December 2023 Fuji Electric Co., Ltd.

Programmable Controller MICREX-F/SX Series Announcement of T-link electric repeater specification change

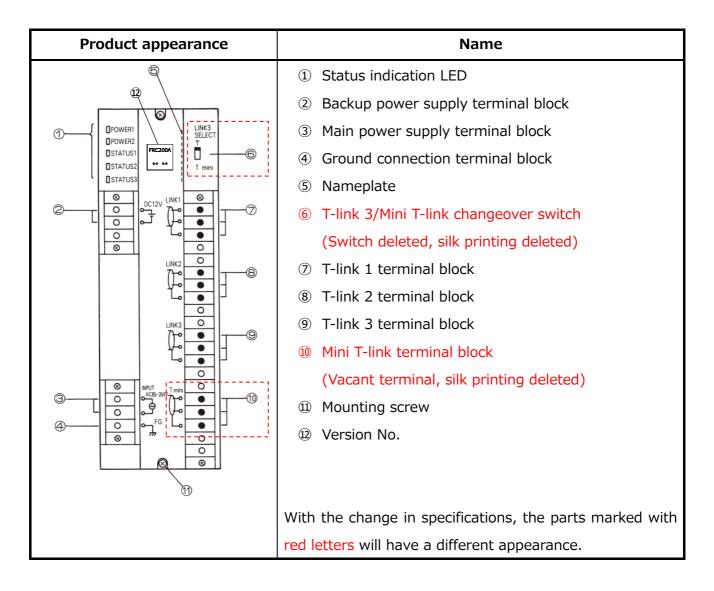
Elimination of mini T-link connection function.

With the elimination of the mini T-link connection function, the T-link 3/mini T-link changeover switch will be deleted. In addition, the mini T-link connection terminal will be left vacant (no internal connection).

Before change: 06 00 After change: 07 00
